# Shepherds Bush Green NW corner

LBHF proposal November 2001

NW corner - Wood Lane is at the top left.

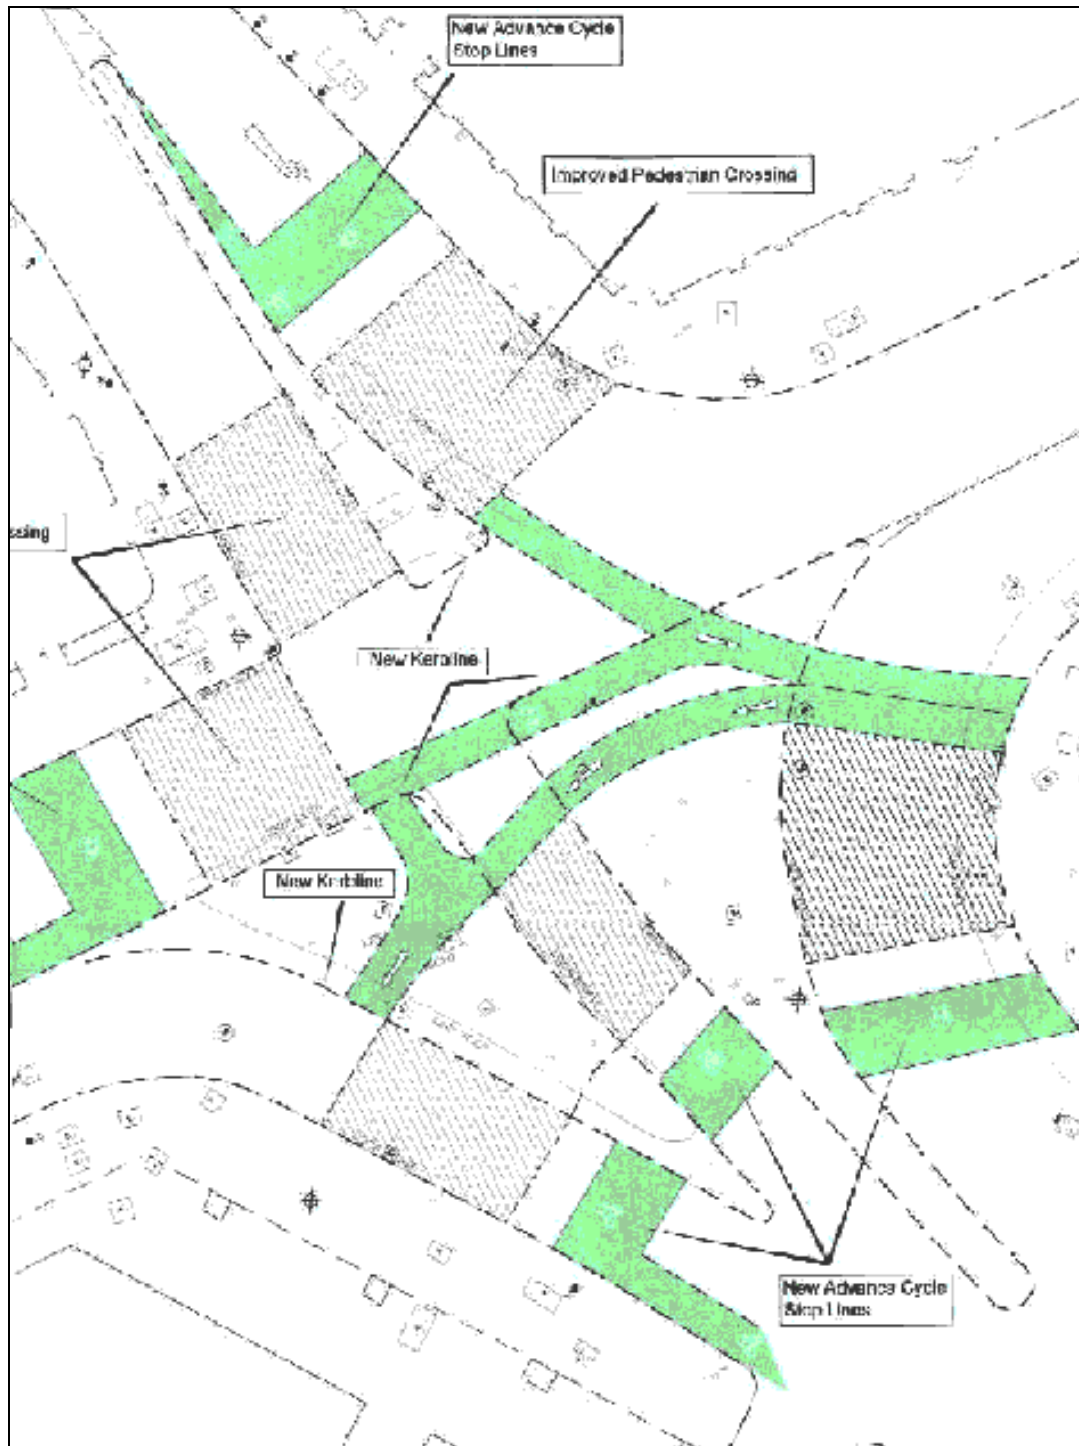
There is no provision for cyclists to go towards the roundabout, as indicated in the architect's proposed cycle provision.

Will these elegant narrow lanes on the islands accept the numbers of cyclists expected to be using them. Especially in the evening rush hour, and with a more than 4x growth in cycling expected in 10 years time.
